Re: **PETITION NO. 1058** - The Connecticut Light and Power Company petition for a declaratory ruling that no Certificate of Environmental Compatibility and Public Need is required for the proposed 1990 line structure replacement project consisting of modifications of two sections of an existing 115-kV transmission line from Stevenson Substation to Frost Bridge Substation and from Baldwin Junction to Baldwin Substation traversing the municipalities of Monroe, Oxford, Middlebury, Waterbury and Watertown, Connecticut – Request to modify the approved landscaping plan at Shaw’s Hill Substation in Watertown.

PLANTING PLAN
SHAW'S HILL 24H SUBSTATION
428 SUNNYSIDE AVENUE, OAKVILLE, CT

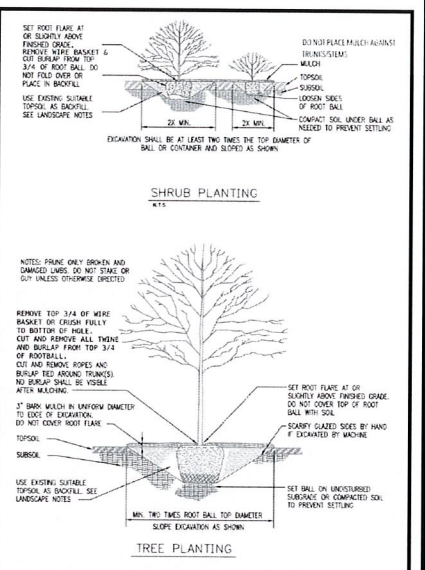
Since that time, Eversource has upgraded its vegetation standards and is currently working to remove “non-compatible” species. That is, species with the potential to intrude within the wire zone. Eversource’s Vegetation Management has reviewed the growth at Shaw’s Hill Substation and determined that modifications are required to the current landscape design to mitigate this risk. As a result, Eversource proposes the attached modified landscaping plan for Shaw’s Hill Substation.

Grind stumps from associated cutting
